FINAL DRAINAGE REPORT

for
HAVEN VALLEY

El Paso County, Colorado

EL PASO COUNTY PCD FILE NO. PUDSP-21-007

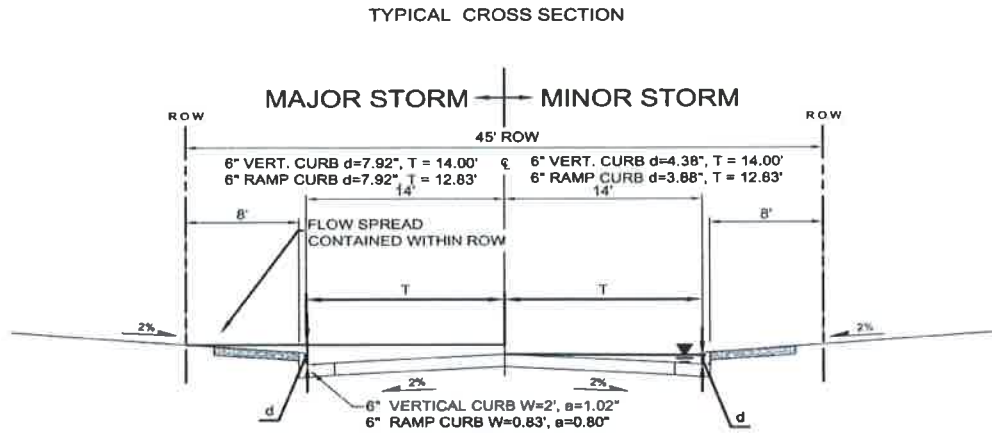
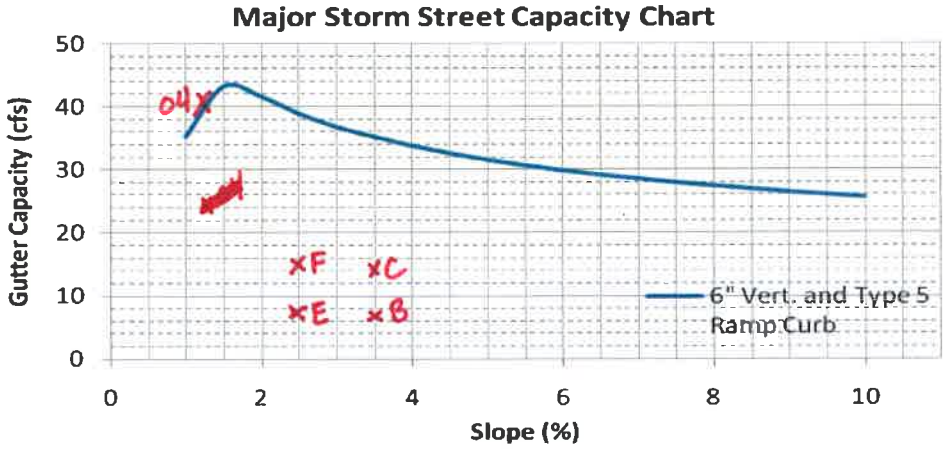
Side slopes do not match what is in the drainage map cross section. Revise.

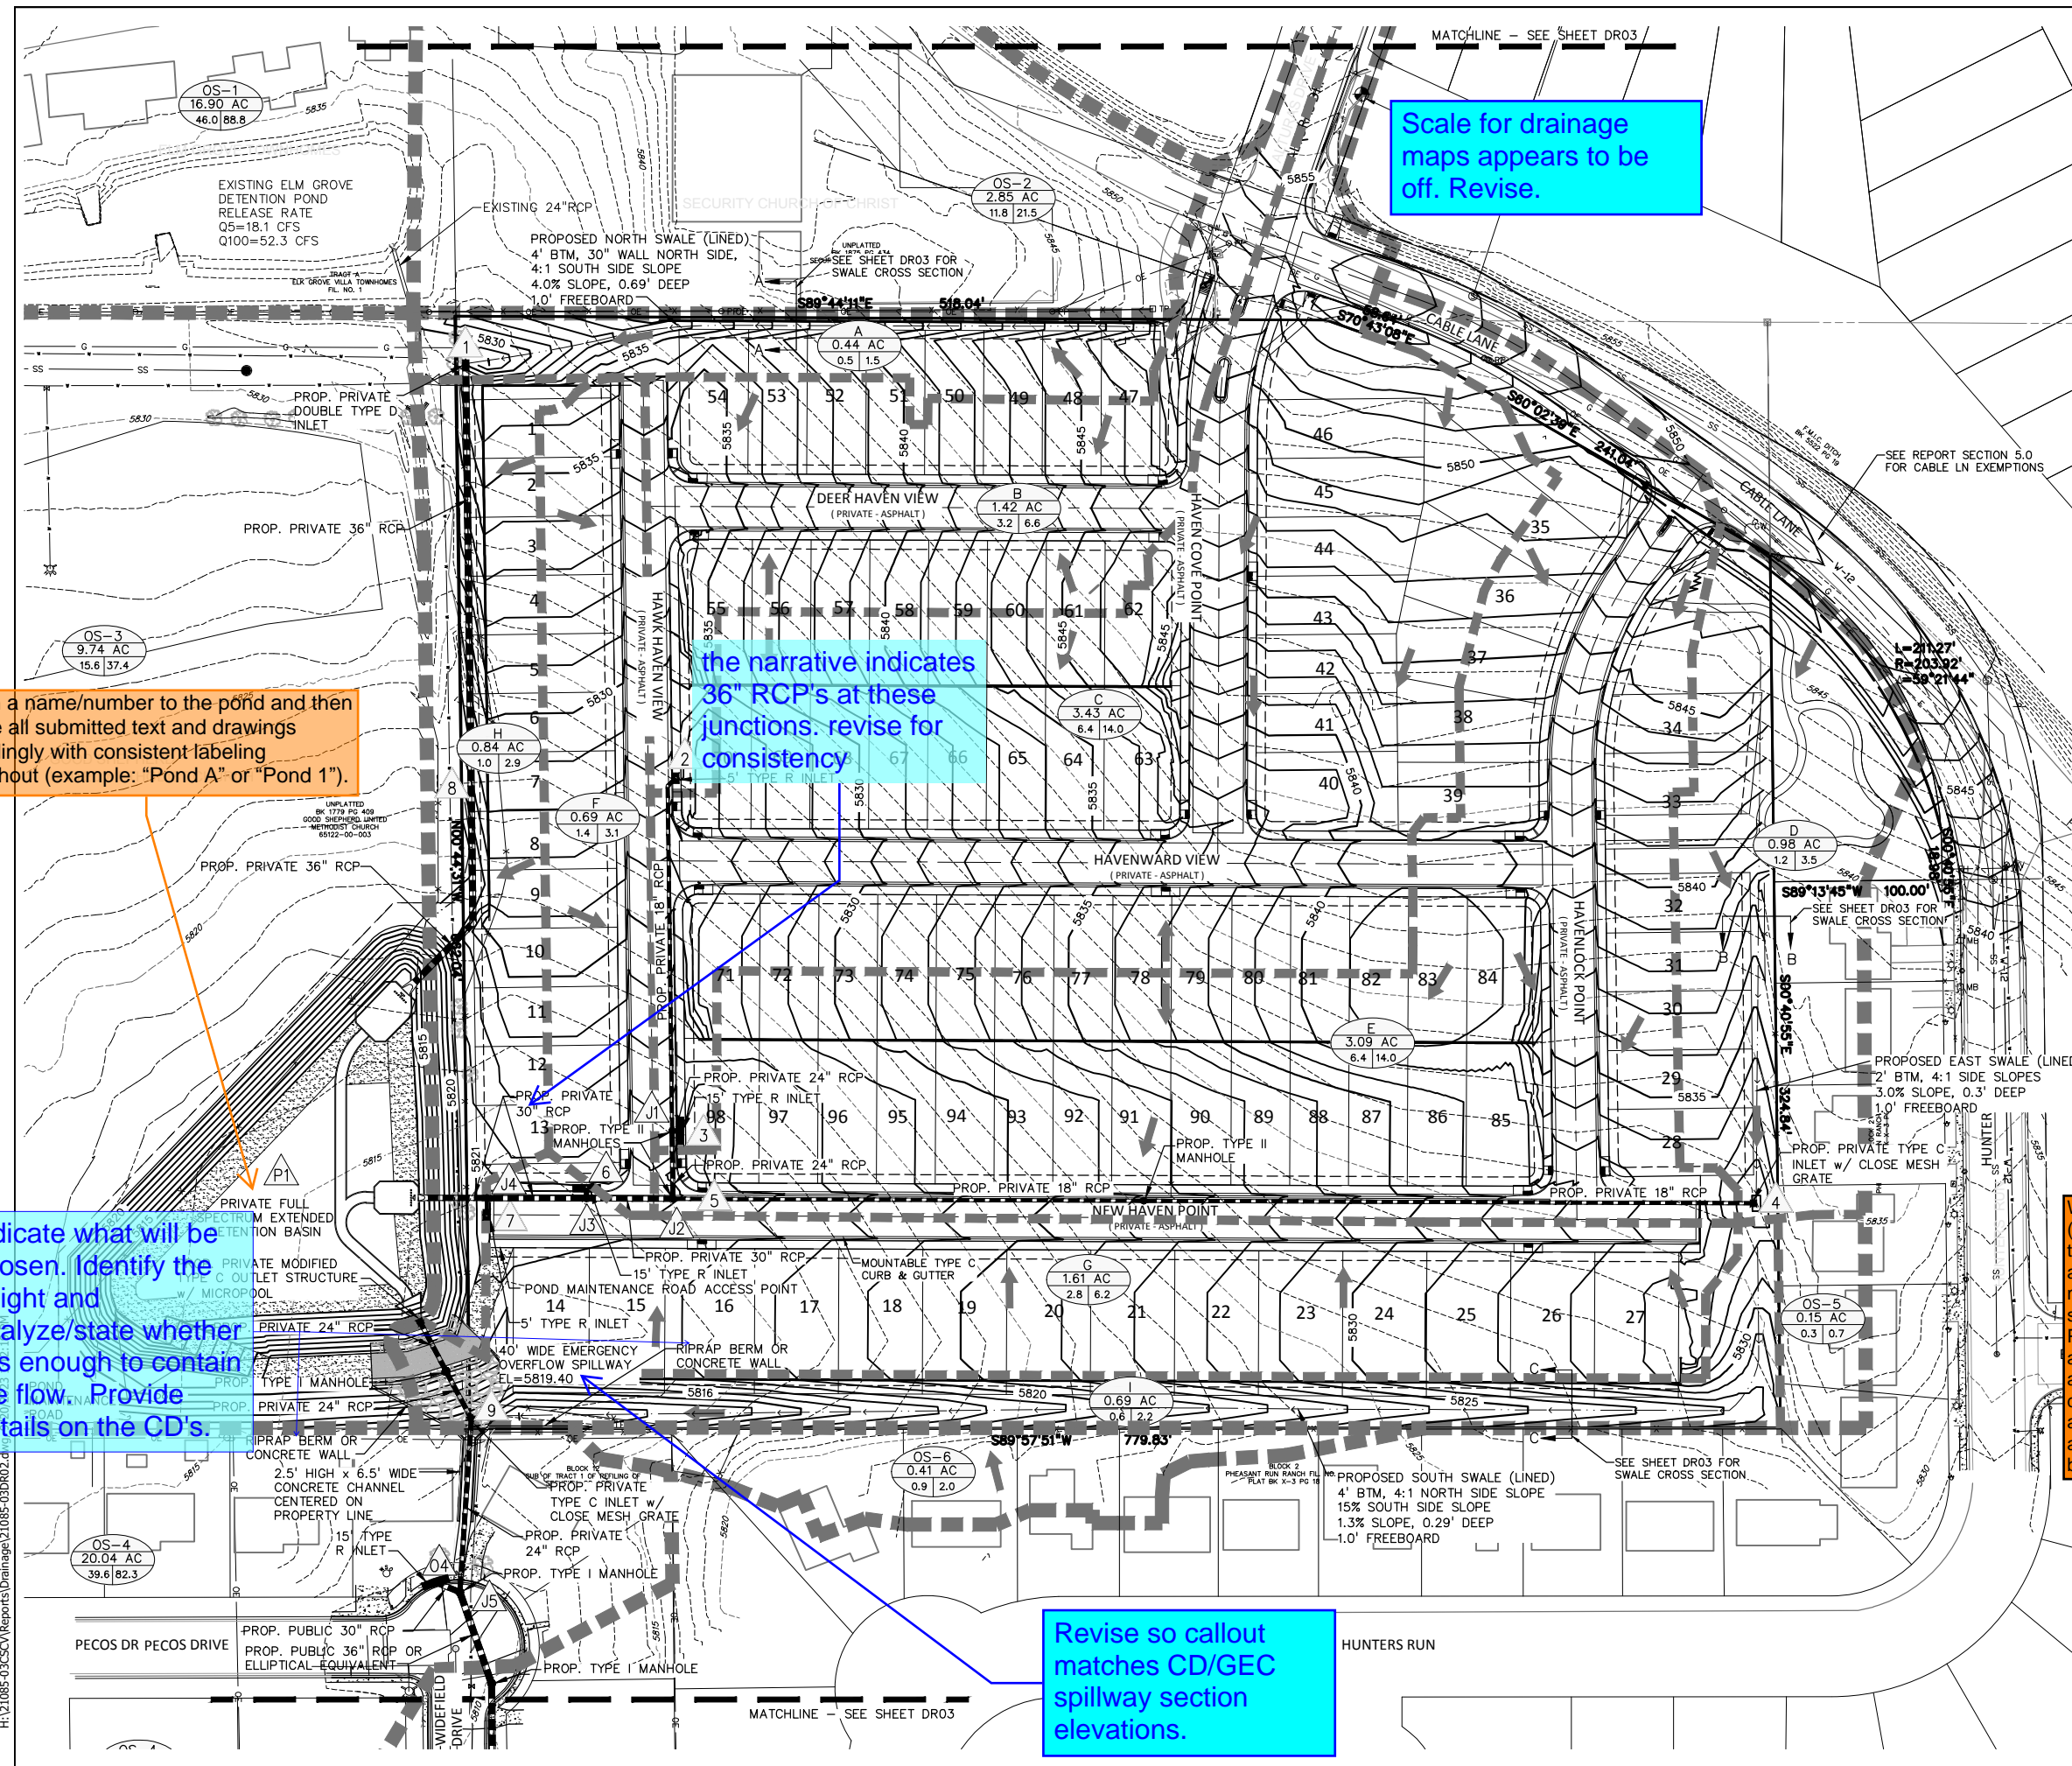
Per DCMv2 – Chap 4.2, trickle channel should at a minimum provide capacity equal to twice the release capacity at the upstream forebay outlet. Provide these calcs in the drainage report and revise plans as needed.

PROPOSED CONDITIONS
DRAINAGE PLAN
 PROJECT NO. 21085-03CSCV
 DRAWING NO.
DR02
 SHEET: 2 OF 3

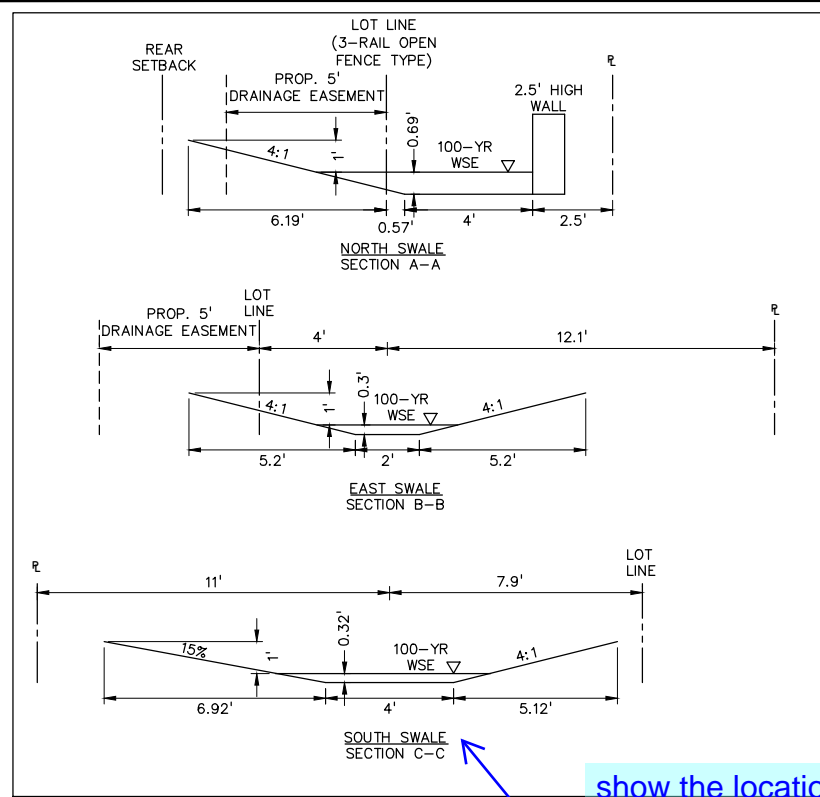
show the location of the retaining wall on this cross section

PROPOSED CONDITIONS
DRAINAGE PLAN

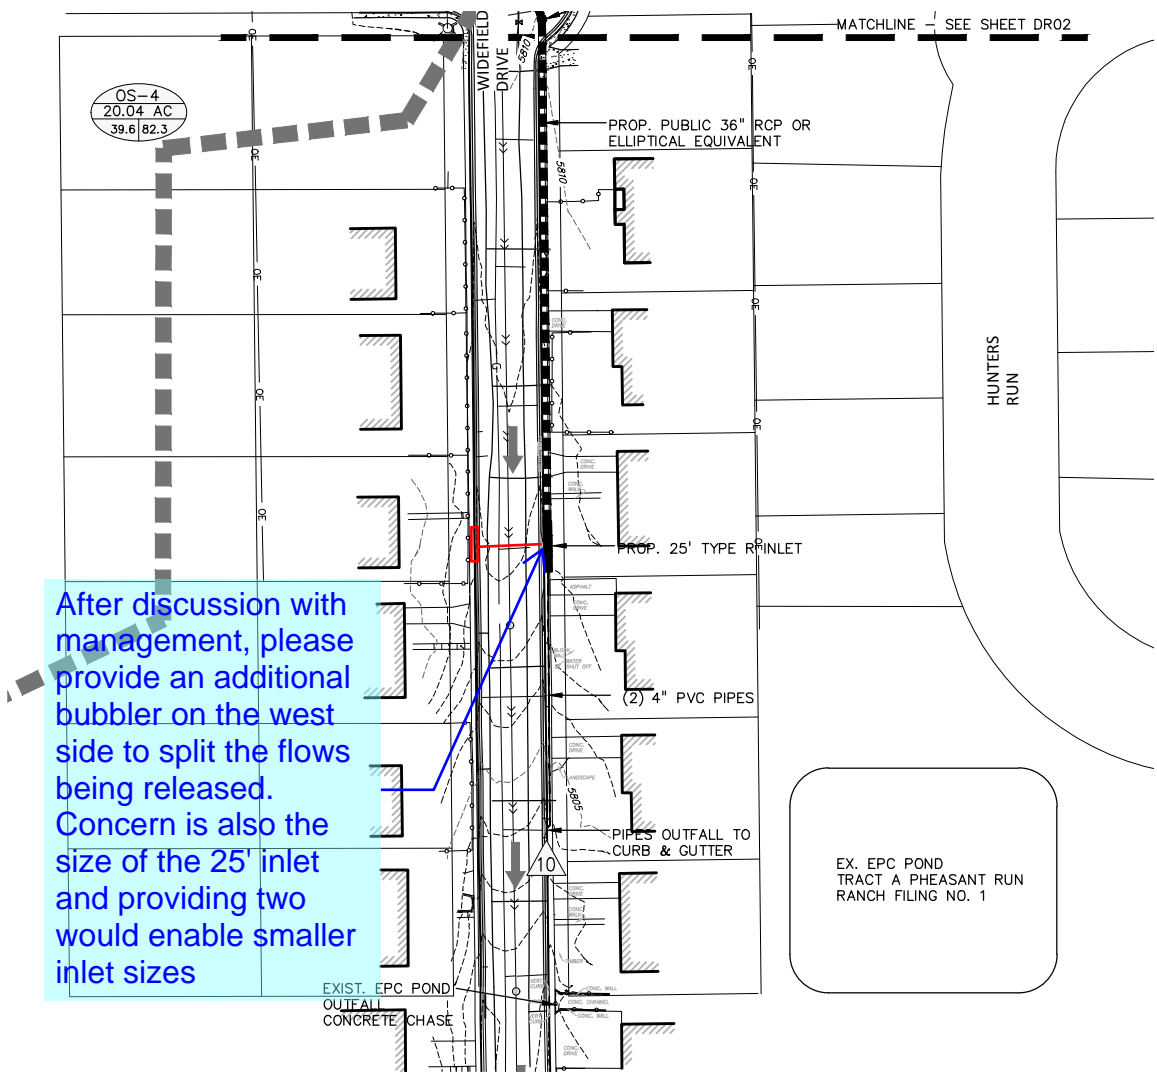
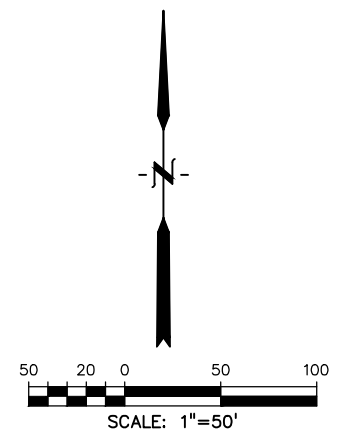
After discussion with management, please provide an additional bubbler on the west side to split the flows being released. Concern is also the size of the 25' inlet and providing two would enable smaller inlet sizes
